Addendum No.1

**To Plans, Contract Documents and Specifications
IFB 15-017/JW, Runway 12-30 Reconstruction**

JACK BROOKS REGIONAL AIRPORT
JEFFERSON COUNTY, TX
RUNWAY 12-30 RECONSTRUCTION

TYPICAL SECTIONS
AND PAVEMENT
DETAILS

1
C-001
**RUNWAY 12-30 RECONSTRUCTION
TYPICAL SECTION**
SCALE: NONE

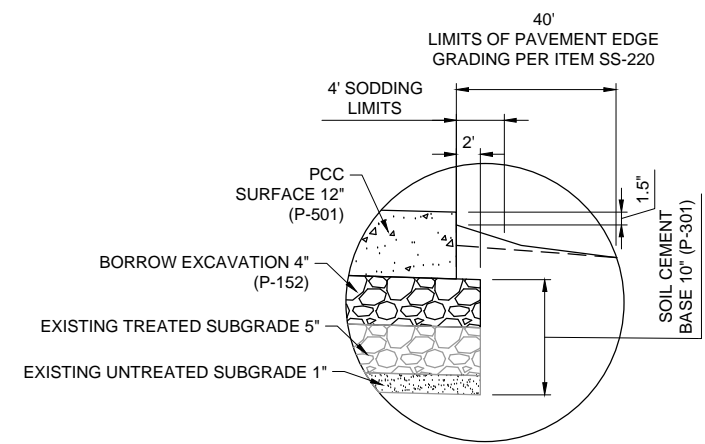
1. **Replace sheet C-001 'Typical Sections and Pavement Details' with the attached sheet C-001 'Typical Sections and Pavement Details'.**

- EXISTING TREATED SUBGRADE THAT IS DETERMINED BY THE ENGINEER TO BE UN-USABLE WILL BE COUNTED AS UNSUITABLE EXCAVATION AND BE REPLACED WITH THE MATERIAL MEETING THE REQUIREMENTS OF SOIL UNDER P-301. MATERIAL WILL BE PAID AS BORROW UNDER ITEM P-152.
- BORROW MATERIAL SHOWN FOR SOIL CEMENT BASE TO BE SELECT FILL WITH A MAXIMUM P.I. OF 20.
